## Watermark Project

# Response to submission from University of New South Wales

Prepared for  
Shenhua Australia Holdings Ltd

**Project number** G1501  
**To** Paul Jackson  
**Company** Shenhua Australia Holdings Ltd  
**From** Neil Manewell  
**Date** 30th September 2014  
**RE** **Response to PAC – Dr Colin Mackie Review**

**Figure 3-1 Cross-section through Southern Mining area/alluvium (Base EIS)**

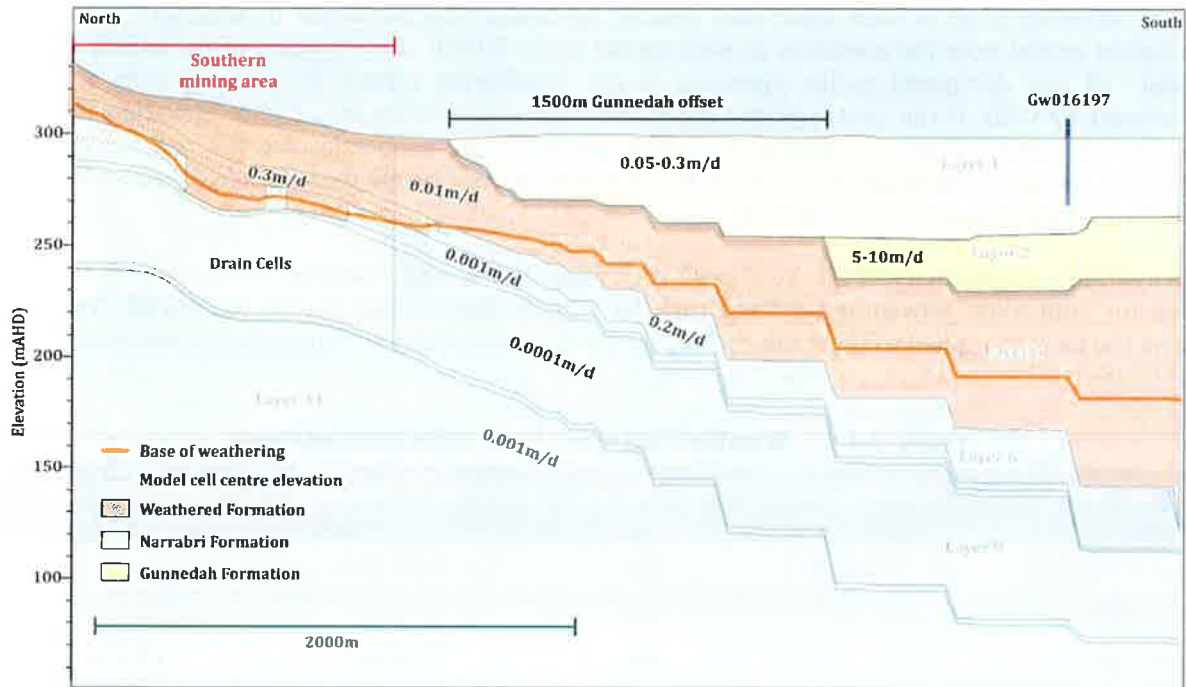
After reviewing a graphic in the EIS UNSW commented that ‘...zones of bedrock weathering that might increase connectivity were not indicated.’ It is correct the graphic did not represent a weathering zone, however the groundwater model did simulate the weathering profile in the proposed mining area and also underneath the alluvial aquifer to ensuring the alluvium and coal measures were represented as hydraulically interconnected.

Figure 3-1 shows a cross-section through the EIS groundwater model, indicating the hydraulic conductivity adopted within each model layer. The mapped depth of weathering has been highlighted to illustrate how the model represented the weathering rock zones.

Figure 3-1 illustrates the groundwater model presented in the EIS adopted a relatively permeable connection (0.01 m/day) between the proposed mining area, and the saturated groundwater system in the alluvial formations.

**Figure 3-3 Cross-section showing colluvial extent (W-E)**

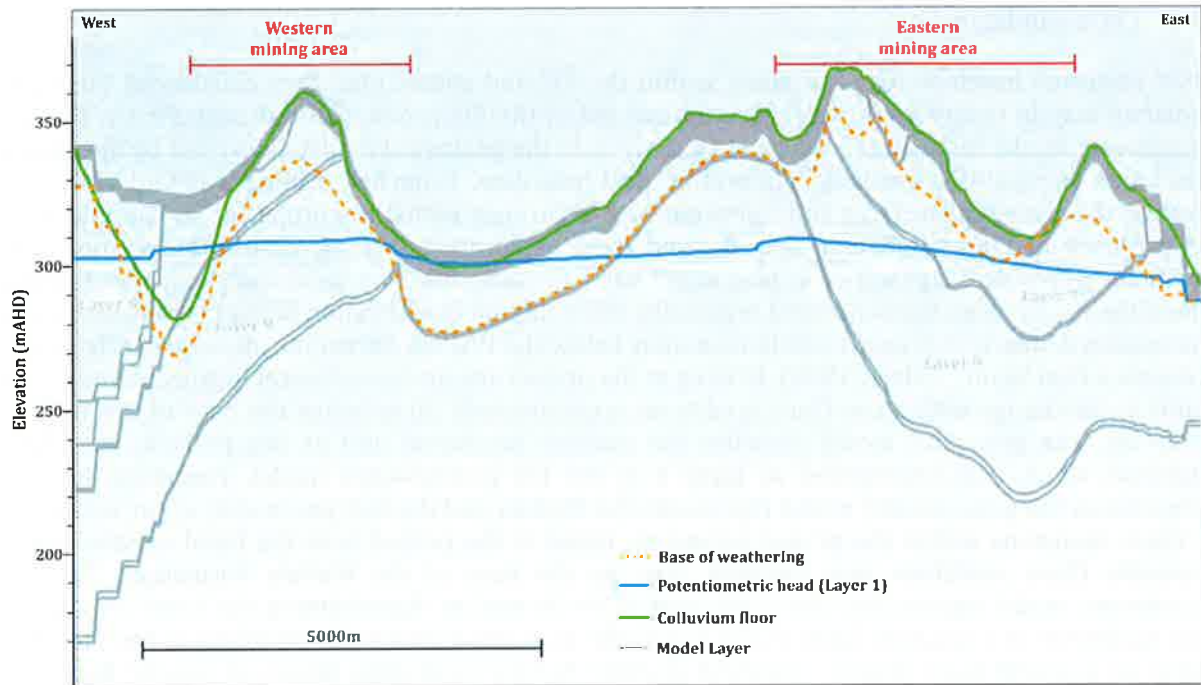
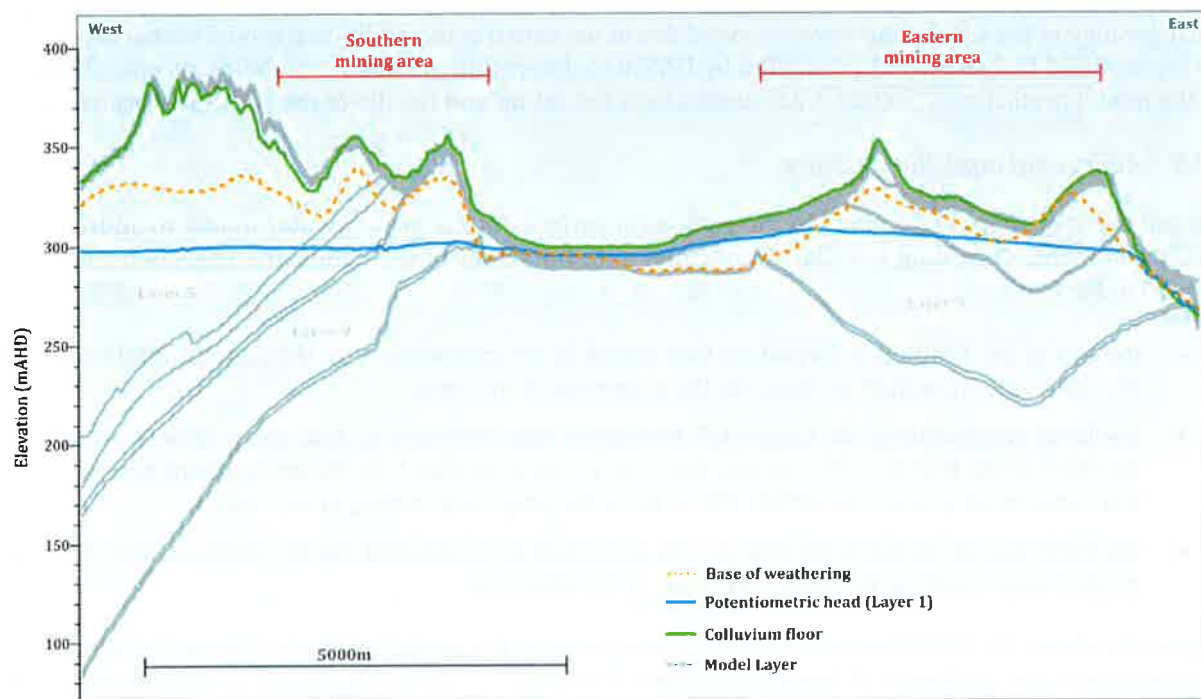
UNSW commented the EIS model did not represent colluvium layers that were depicted in geological cross sections. The EIS model did represent the presence of colluvium, not as a discrete model layer, but as part of the weathered zone. The colluvium, by its nature is a relatively thin, of limited extent and is largely unsaturated over the majority of the project area. Figure 3-3 and Figure 3-4 show cross sections through the EIS groundwater model with the mapped floor of the colluvium, the weathering surface and water table simulated in the model.

The figures highlight that representing the colluvium with the weathered material readily accounts for this relatively insignificant unit. The colluvium is only saturated in a small area adjacent to the Western Mining area. There are two monitoring bores installed in this area (WM0035A and WM0293A). Permeability testing of the colluvial deposit recorded a relatively low permeability from 0.0006 to 0.008 m/day. The hydraulic conductivity of the model layers where the colluvium exists in the saturated zone is 0.01 m/day, which is conservatively high and considered an appropriate representation of this unit in the EIS model.

**Figure 3-18 UNSW Impact Graphic**

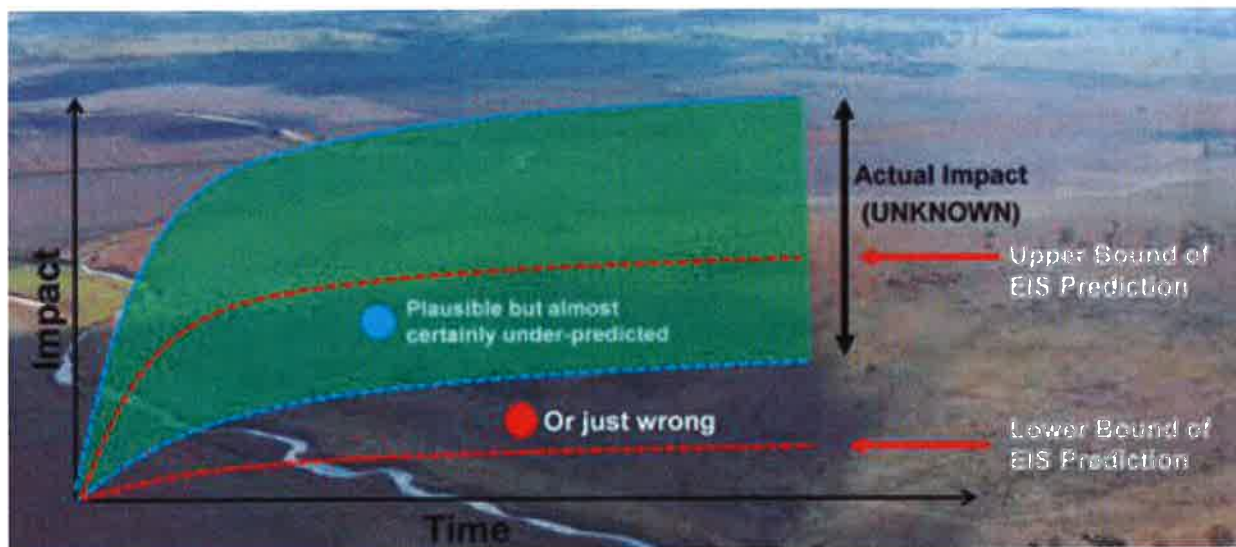
UNSW consider good science provides a plausible and conservative estimate of impacts, and go on to conclude the groundwater assessment for the Project was *'plausible but almost certainly under-predicted, or just wrong.'* They show this graphically in their presentation as reproduced in Figure 3-18 below.

UNSW appear to reach this conclusion simply because the groundwater model was not set up in a manner they would recommend. Of course we understand there are many different ways to represent natural processes in models, but UNSW appear to conclude without any modelling evidence, that because the model was not set up in a manner they would recommend the impacts predicted by the EIS must be under-predicted or wrong. They don't seem to consider the scenario that setting the model up in a manner they recommend could result in lesser impacts.

**Figure 2-1 Groundwater recovery of the waste rock areas (EIS model)**

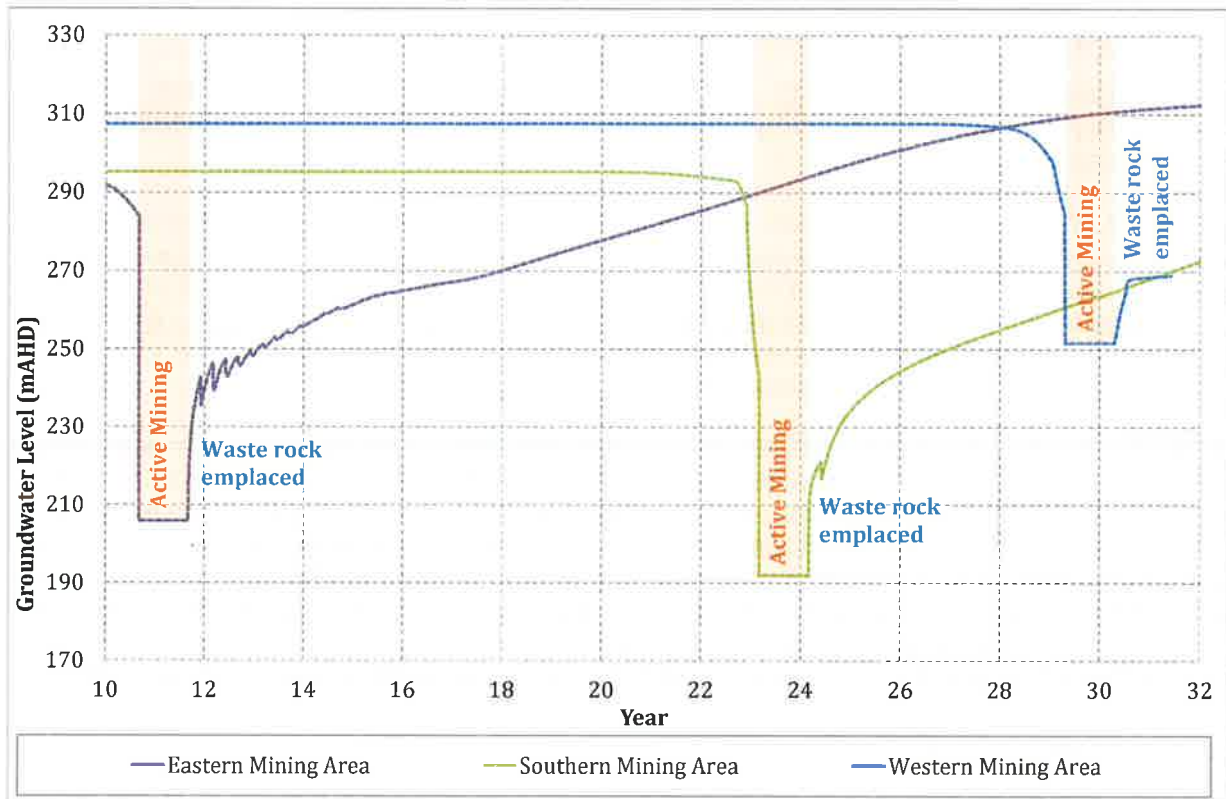
Dr Mackie raised a concern that the EIS model which emplaces spoil behind the active mining area (in line with the Project mine plans) might be buffering the drawdown impacts by allowing water pressures within the mined areas to begin recovering after mining passes through.

The results show a rapid recovery following the emplacement of spoil (~30m after 90 days), although a groundwater sink for regional groundwater levels remains for approximately 10 years after the closure of each mining area. For this reason, it is considered the recovery of groundwater levels within the spoil does not overly influence the regional groundwater drawdown predictions, and the staged approach adopted by the EIS model is valid, assuming the mine plan is implemented as proposed.

**Figure 2-12 Cross section of water table surface (EIS model)**

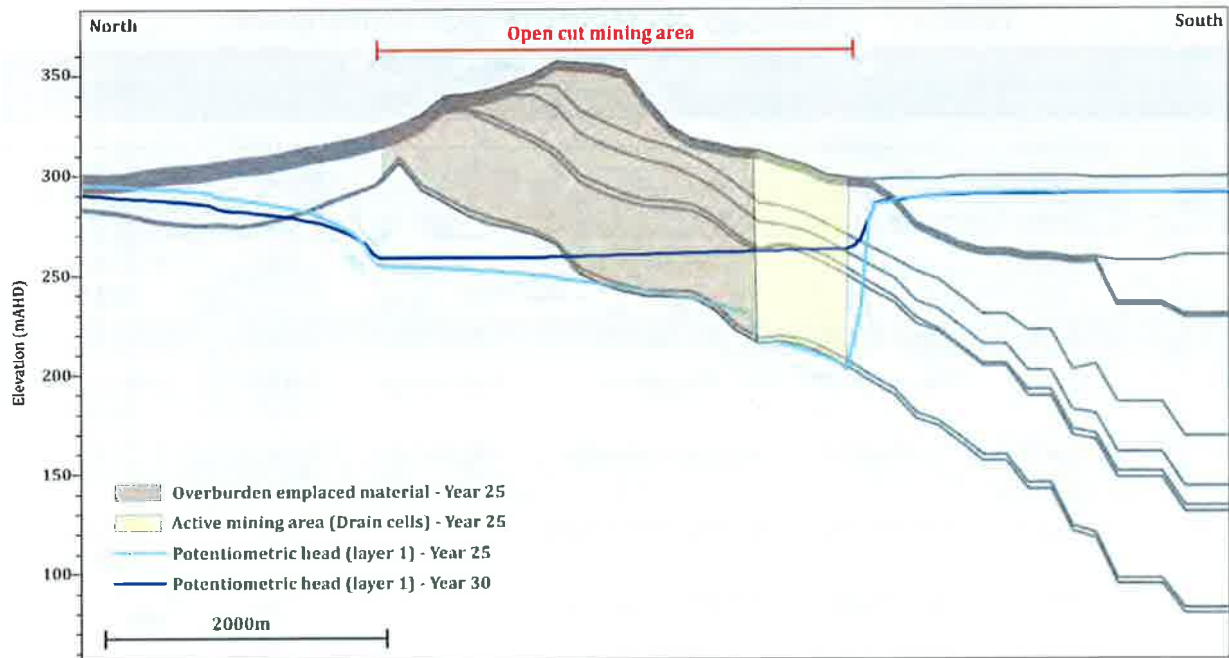
Dr Mackie also noted that: *“Figure 6 represents the EIS model with pore pressures indicated by the white contours. Close inspection of the zero pore pressure (water table) contour in the Southern Pit shows a highly erratic surface. Normally are relatively smooth surface that reflects the floor of the mined coal seam, would be expected (see Figure 7 for dewatered pit profile). The erratic surface identified in Figure 6 may be indicative of more general problems probably associated with recharge to spoils, or to unconventional assignment of drain cells or possibly discretisation issues. It is important to identify the reason for this behaviour since it may have implications for regional water table drawdown and mine water inflows.”*

Upon analysis of the groundwater potentiometric heads, there is no visible erratic behaviour of the groundwater potentiometric surface throughout the model run. AGE provided Dr Mackie a figure which represented a model cell pressure head, which was contoured against the finite difference cell centres in the groundwater model. As such, the zero pressure contour represented an interpolated saturation surface, which was intended to display absolute saturation extents rather than represent the saturation surface. Graphical user interfaces (e.g. Groundwater Vistas 6) perform additional corrections in cells experiencing unconfined conditions ensure the zero pressure head contour is equal to the water table.

Figure 2-12 shows the water table surface at years 25 and 30 for the EIS model. Clearly, there is no erratic behaviour in the groundwater levels, and the re-saturation of groundwater levels in the waste rock appears realistic.
